# PREVOST

## WARRANTY BULLETIN

**WB15-06C**

DATE :	FEBRUARY 2015	SECTION :	06 - Electrical
EXPIRATION:	FEBRUARY 2017		
SUBJECT :	067954 CURRENT SENSOR INSPECTION AND REPLACEMENT

Figure 6: Typical Current Sensor.

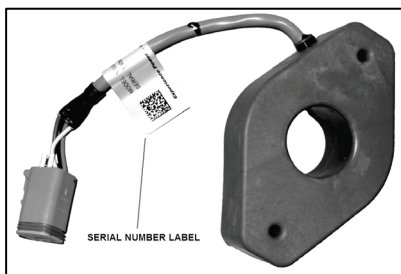
2. Locate sensors next to batteries (Fig 7 & 8). Defective Sensors have a serial number starting with **14300, 14307 or 14314** (Fig 6). If found, consult **Table 2** below to confirm serial number is part of list.

Figure 11 : H Series Power Cables

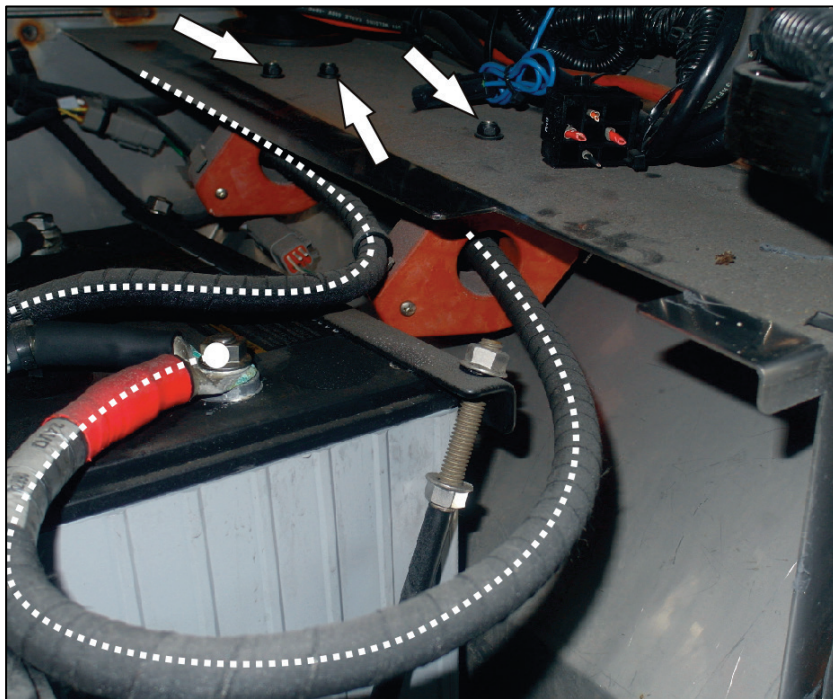
6. Remove 12V and / or 24 V power cables to allow sensor removal. (Fig. 11 & 12)

12. Replace sensor by a new #067954.
13. Make sure new part's serial number is not part of defective list in table 2.
14. Reconnect 12V and / or 24 V cables. Tighten to 170 lbf-in (14 lbf-ft)
15. Reconnect ground cable last. Tighten to 170 lbf-in (14 lbf-ft)

Figure 13 : H series sensor mounting screws

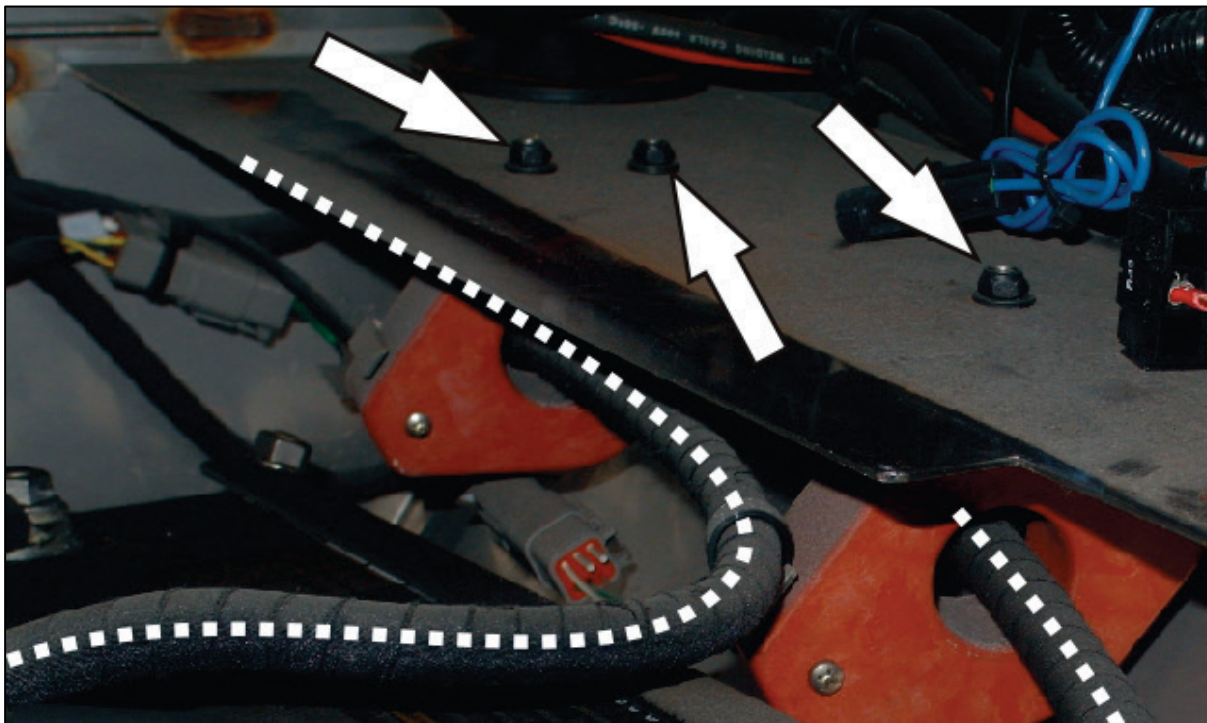
7. Remove sensors (Fig. 13 & 15)
8. H Series: remove mounting plate nuts. Reserve for re-assembly.
9. Remove Sensor mounting screws on a workbench.  
(Mounting Screw #5001694 Pan Head, Philips M4 x 40mm)

Figure 15 : X series sensor mounting screws

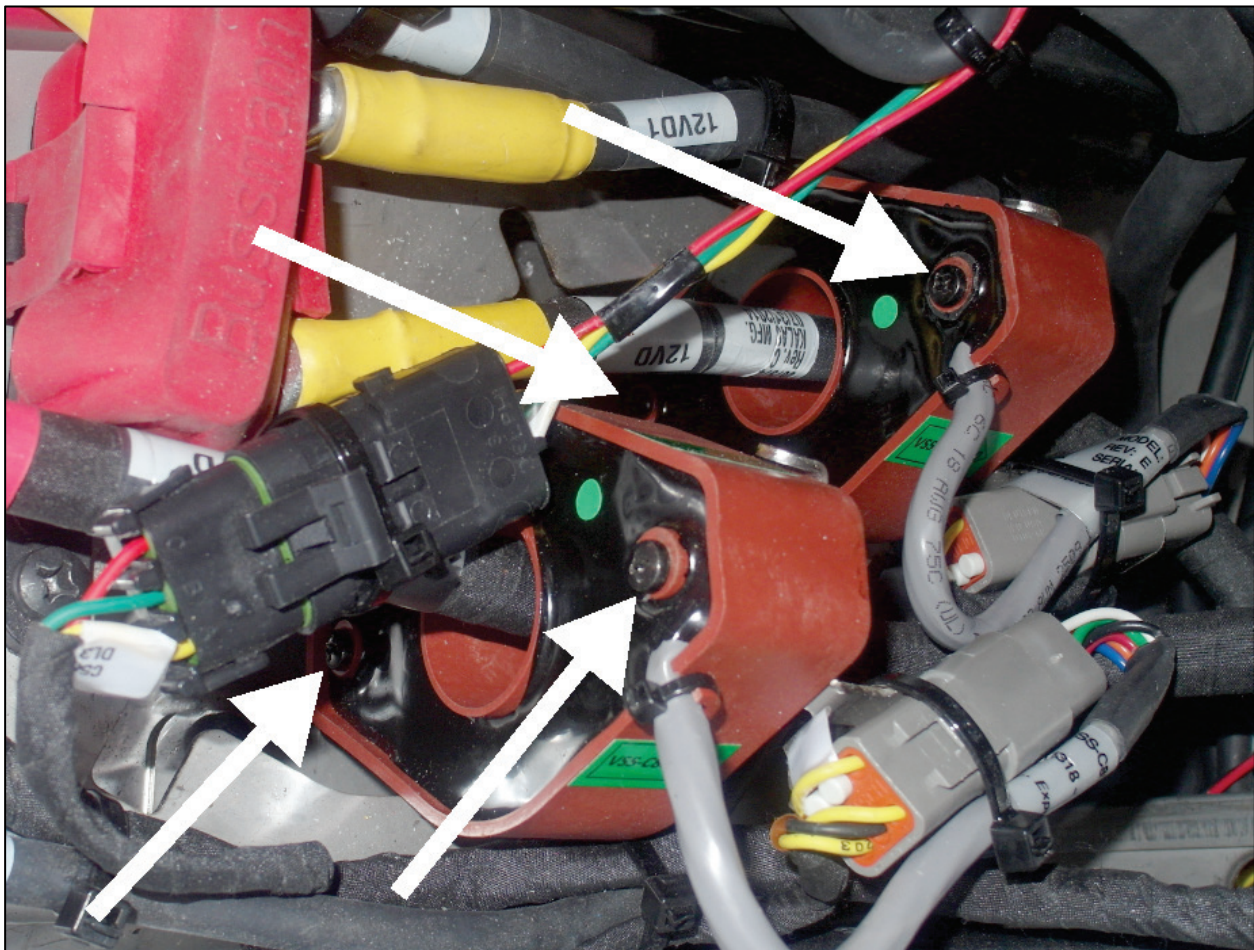
11. X Series: To remove the lower screws, use the smallest ratchet possible and a flex ratchet extension (Fig. 1, 2). (Mounting Screw #5001694 Pan Head, Philips M4 x 40mm)
